Access Compliance Report

Public Rights-of-Way

(Curb Ramps)

Intersection ID: 11025	Main Street: CAMP_GREENE_ST	Cross Street: ELON_ST	Location: SW
ADA ID: FEB51A82B057	Ramp Type: Directional1	Initial Pass/Fail: Fail	Overall Compliance: No
Codes/Mitigation Info/Possible Solution		Field Measurements/Component Compliance	
Severity Score: 1.25

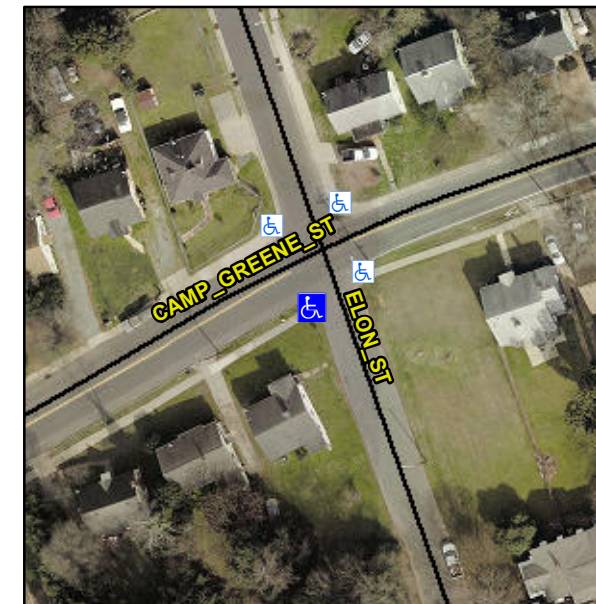
R304.5.3

Compliance	Description	Data	Compliance	Description	Data
N/A	Ramp Length (in)	118.0	N/A	Grade Break?	N/A
Yes	Ramp Width (in)	58.5	N/A	Grade Break Slope (%)	0.0
Yes	Ramp Slope (%)	8.0	N/A	Grade Break XSlope (%)	0.0
No	Ramp XSlope (%)	2.4			
N/A	Flare Type LT	N/A	N/A	Flare Type RT	N/A
N/A	Flare Slope LT (%)	N/A	N/A	Flare Slope RT (%)	0.0
N/A	Flare Traversable LT?	N/A	N/A	Flare Traversable RT?	N/A
N/A	Landing Length (in)	0.0	N/A	DWS Provided?	N/A
N/A	Landing Width (in)	0.0	N/A	DWS Contrast?	N/A
N/A	Landing Slope (%)	0.0	N/A	DWS Length (in)	N/A
N/A	Landing X Slope (%)	0.0	N/A	DWS Full Width?	N/A
N/A	Landing Curb? (Y/N)	N/A	N/A	DWS Offset LT (in)	N/A
N/A	Shared Landing?	N/A	N/A	DWS Offset RT (in)	N/A
N/A	Gutter Ponding?	0.0	N/A	Gutter Slope (%)	N/A
N/A	Gutter Lip Ht (in)	0.0	N/A	Gutter X Slope (%)	N/A
N/A	Painted X Walk1?	No		Road Slope (%)	6.5
	X Walk 1 Direction	To E		Road X Slope (%)	4.2
	X Walk 1 Width (in)	N/A		Clear Space?	N/A

Remove & Replace Entire Ramp.
